REPORT OF THE TECHNICAL COMMITTEE ON OBJECTIONS TO PROPOSED DECISION

TO:	Directors	
FROM:	Technical Committee	Environmental Licensing Programme
DATE:	22 August 2019	
RE:	Objection to Proposed Decision for Clashford Recovery Facilities Limited, Naul Townland, Naul, County Meath. Waste Reg: W0265-01.

Appendix 1: Current Surface Water Discharge Points - Figure No. F1.0 dated 8/07/18.

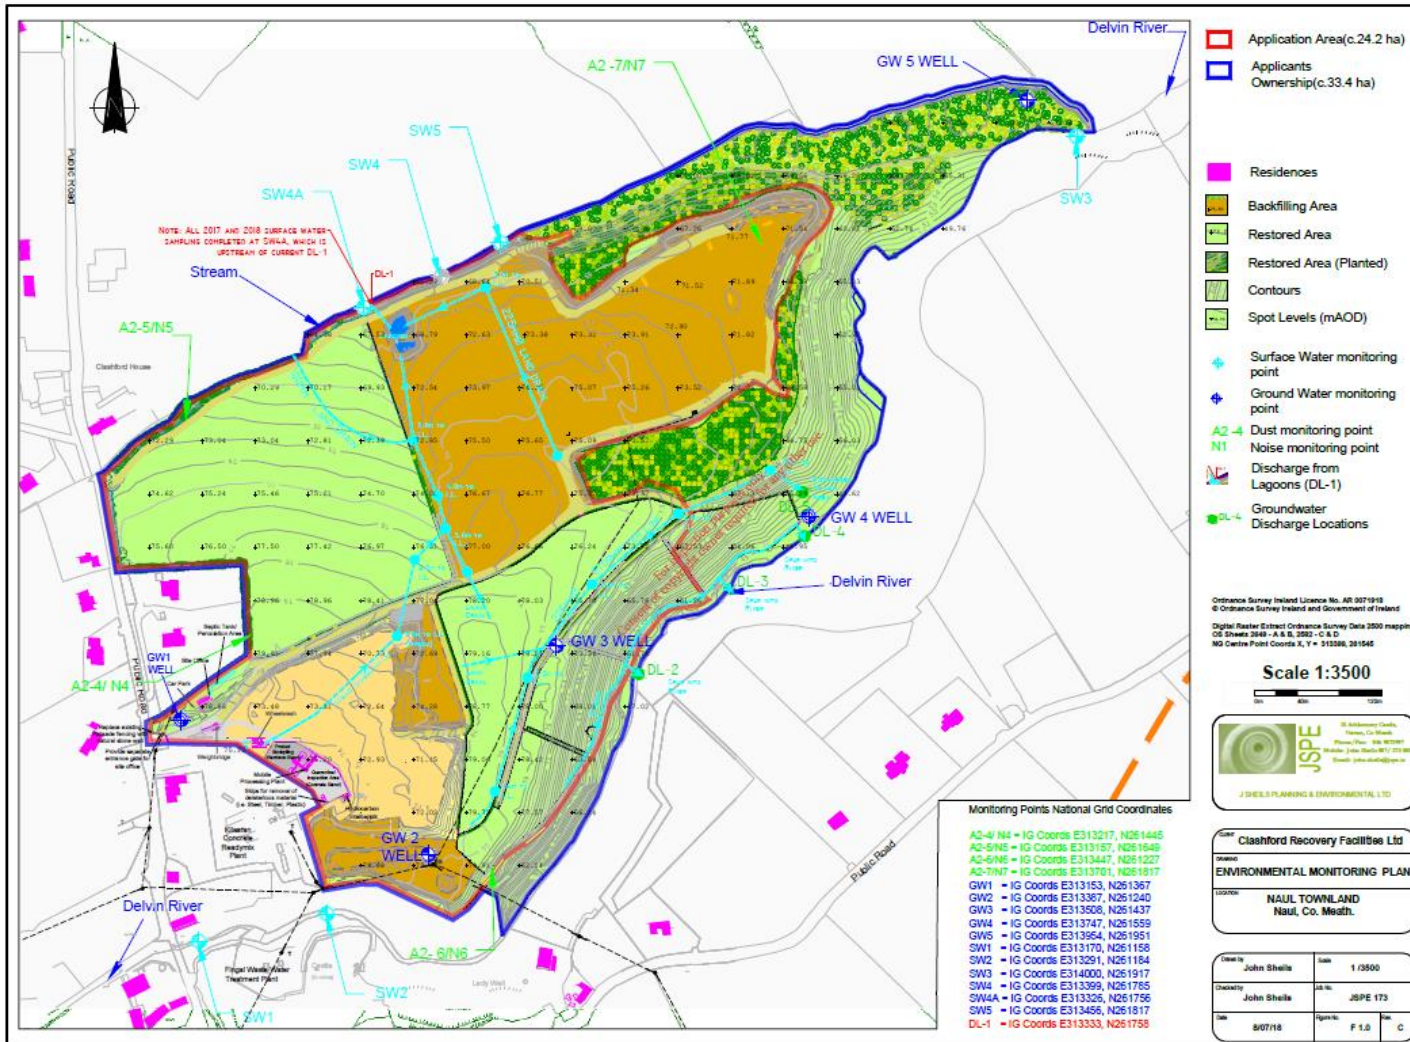
As from Figure No. F1.0, dated 8/07/18 in Appendix 1, it was not clear that the downstream surface water monitoring point SW4 was redundant. As monitoring point SW5 is also located downstream it is considered reasonable to remove SW4 from Schedule C.1.2 and update the Schedule to reflect the changes made in Schedule C.1.1.

3.11.2 Prior to commencement of waste acceptance, infrastructure associated with Storm water Discharge Point Reference No.: DL-2, DL-3, DL-4 and DL-5, as shown on Figure No. F1.0 Rev C, dated 8/07/18, shall be decommissioned to the satisfaction of the Agency.

Appendix 2: Proposed Surface Water Discharge Points - Figure No. F1.0 Rev D, dated 28/04/19.

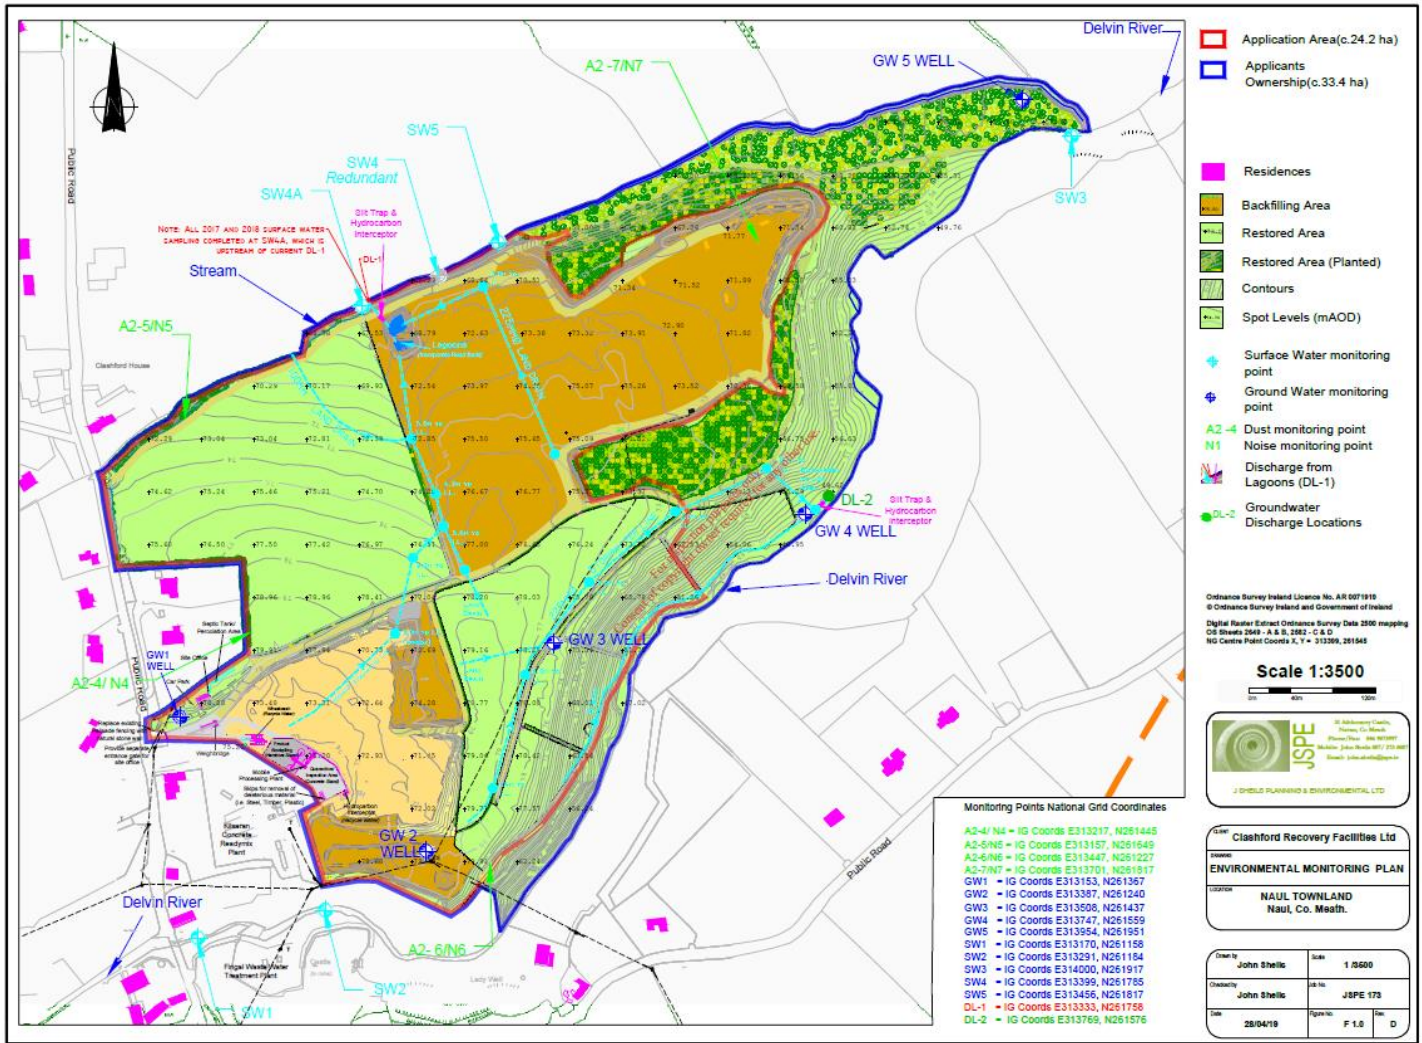
The applicant objects to Schedule C.1.1 and proposes that it would be more appropriate to seal off three of the discharge points to the River Delvin in order to provide a single discharge point (DL-2) as shown on Figure No. F1.0 Rev D, dated 28/04/19 in Appendix 2.

- Changes following the update of Schedule C.1.1 as per A.10 above, and
- Schedule C.1.2 refers to storm water monitoring points which are upstream and downstream of the current proposed discharge points. As shown on Figure No. F 1.0 Rev D, dated 28/04/19 in Appendix 2, storm water monitoring point SW-4A is located upstream of stormwater discharge point DL-1, while monitoring point SW4 and SW5 are located downstream of DL-1. The applicant states that SW4 is redundant and should be removed from the schedule.

Combining the four discharge points to the River Delvin into one single discharge point is a practical approach to managing storm water discharge at the facility. Discharging through a single emission point will also provide a more convenient and cost effective option to comply with Condition 3.15 and Schedule C.1.1, which requires all storm water to pass through a silt trap and oil interceptor. Similarly, flow monitoring in accordance with C.1.1 may be more practical from a single discharge point and also compliance with Condition 6.11, which requires a daily visual examination of storm water discharges and diversion of storm waters for retention and suitable disposal in the event of trigger value exceedances.

To ensure compliance with storm water management at the facility, the decommissioning of infrastructure at discharge points DL-2, DL-3, DL-4 and DL-5 is recommended, along with the installation and commissioning of the new combined DL-2 discharge point, prior to commencement of waste acceptance. It is therefore recommended to amend Schedule C.1.1 and subsequently Condition 3.11 Storm Water Management, Schedule C.1.2 Monitoring of Storm Water Discharges and Schedule D Specified Engineering Works, to reflect the change. Update of C.1.2 is addressed in A.11.

3.11.3 Prior to commencement of waste acceptance, infrastructure associated with Storm water Discharge Point Reference No.: DL-2, as shown on Figure No. F1.0 Rev D, dated 28/04/19, including silt trap and oil interceptor, shall be installed and commissioned to the satisfaction of the Agency.
